# The Light company

October 14, 1985  
ST-HL-AE-1389  
File No.: G9.17

South Texas Project  
Units 1 and 2  
Docket Nos. STN 50-498, STN 50-499  
Responses to DSER/FSAR Items Regarding Section 3.6

Figure 3.6.1-1 SH 3A

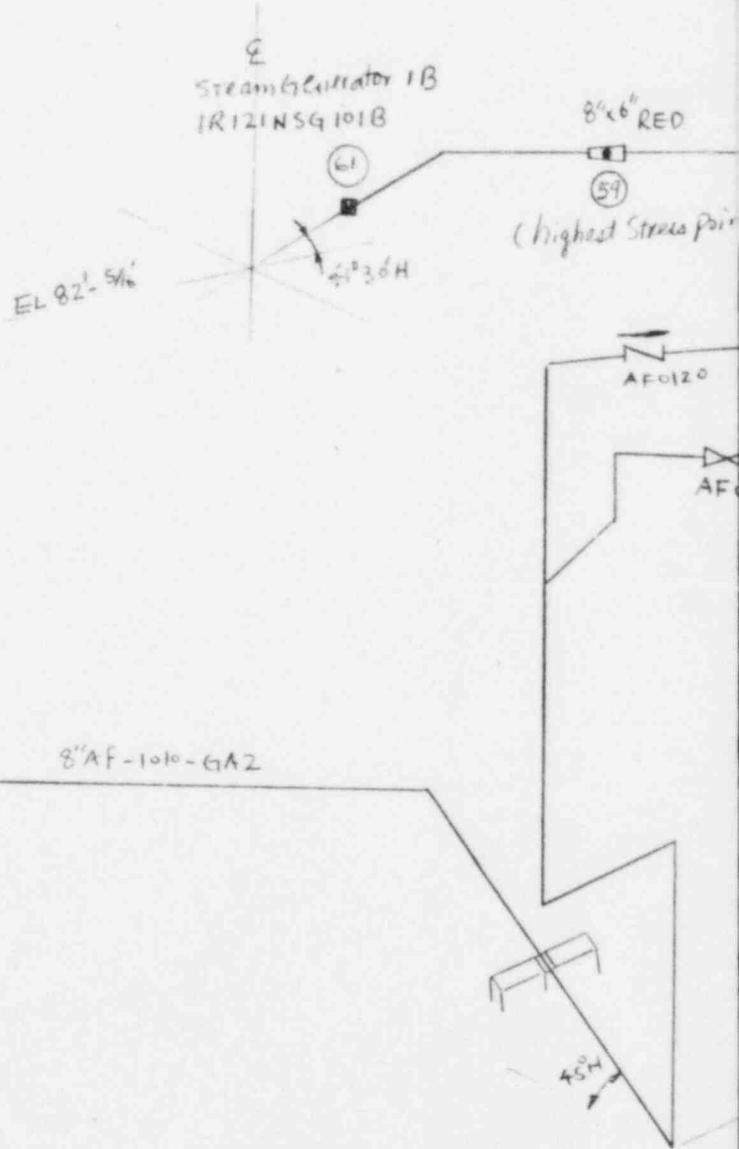
In order to assure that the pipe break criteria have been properly implemented, the Standard Review Plan requires the review of sketches showing the postulated rupture locations and of summaries of the data developed to select postulated break locations including, for each point, the calculated stress intensity, the calculated cumulative usage factor, and the calculated primary plus secondary stress range. The required sketches and tables for some high energy piping systems have not been provided at this time in the FSAR. Provide a schedule for submission of these data.

Initial stress summaries regarding pipe break locations, stress levels, cumulative usage factors ~~will be provided during the fourth quarter of 1985.~~ *are shown in FSAR Table 3.6.2-1. Sketches showing pipe break locations are provided in FSAR Figure 3.6.1-1.*  
Final design information, including as-built reconciliation, will be provided prior to fuel load.

FIGURE 3.6.A-1

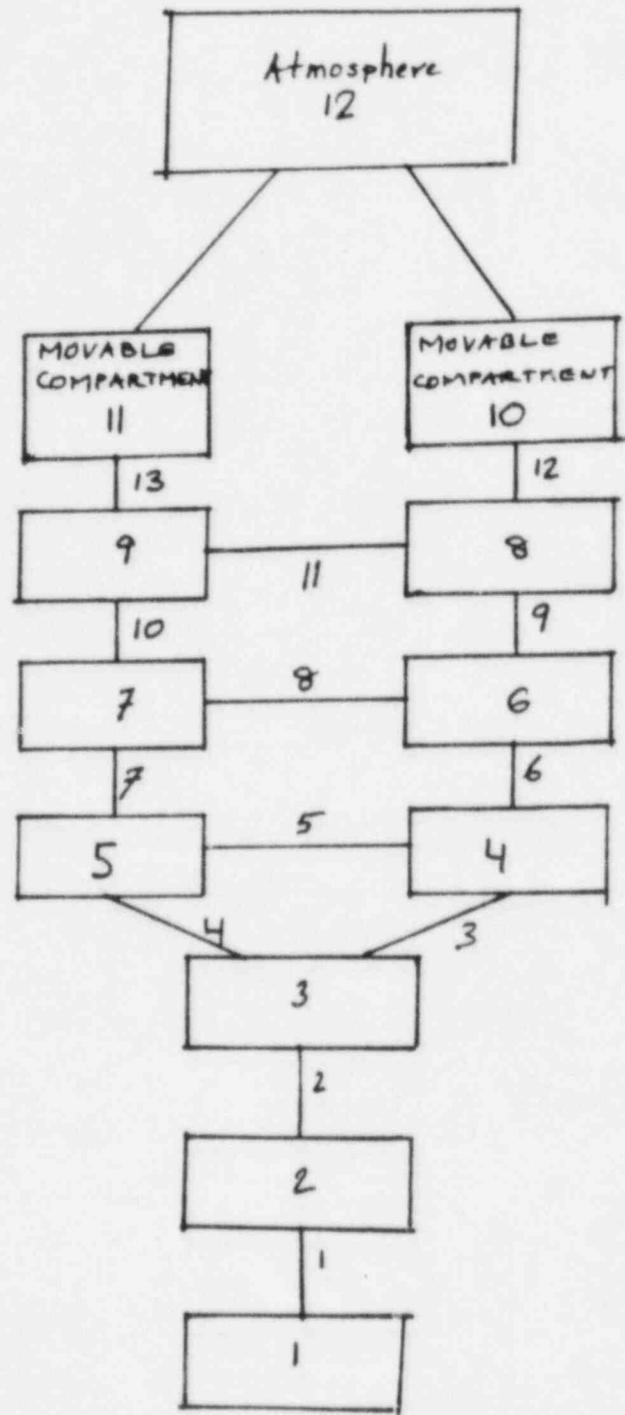
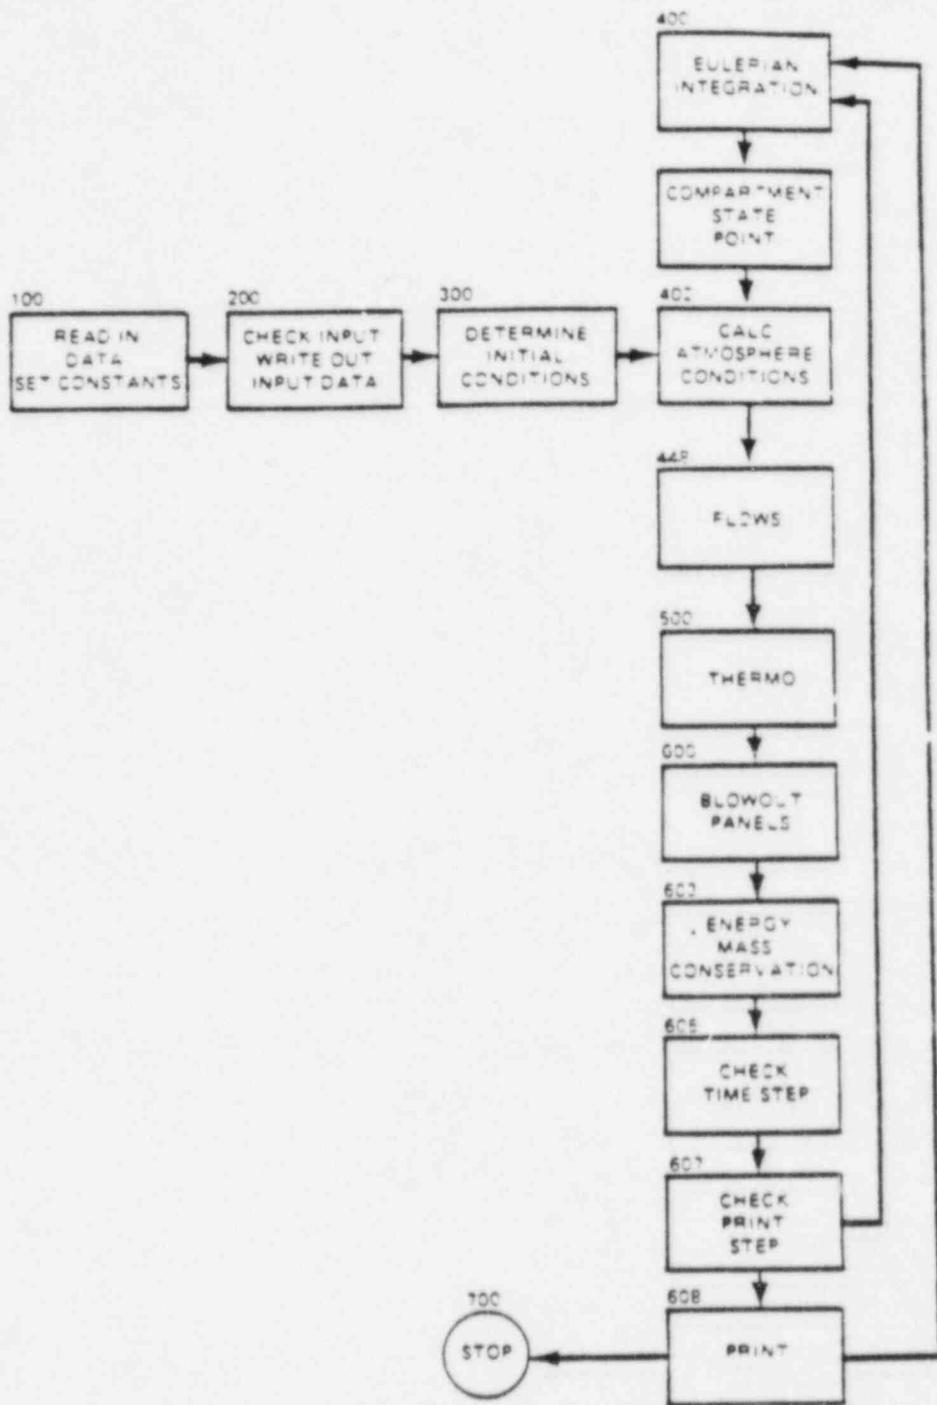
During our review of your Report No. LO1ORR064A, "Report on Dynamic Effects of Postulated Piping Failures Outside the Containment," you proposed to redesign your main steam and feedwater valve compartment to consider the environmental effects (pressure, temperature, humidity) and potential flooding consequences from an assumed crack, equivalent to the flow area of a single ended pipe rupture in these lines inside the valve compartment. Provide your design modification and the related safety analysis, including the following:

1. Describe the location and size of the vent areas in the main steam and feedwater valve compartment.
2. We require that essential equipment located within the compartment including the main steam isolation and feedwater valves and their operators be qualified to operate in the environment resulting from the above assumed single ended pipe rupture. State your intent with regard to this position.
3. Provide a subcompartment pressure analysis to confirm that the design of the main steam and feedwater valve compartment can withstand the effects of the above assumed single ended pipe rupture. When you submit the subcompartment pressure analysis, identify the computer code used, the assumptions used for mass and energy release rates, the length of time blowdown exists, and sufficient design data so that we may perform independent calculations.

As discussed in revised Section 3.6, an Appendix will be provided that describes the evaluations made of the effects of postulated pipe failures within the plant. A discussion of the effects of postulated failures within the Isolation Valve Cubicle ~~will be included~~ <sup>is</sup> provided in FSAR
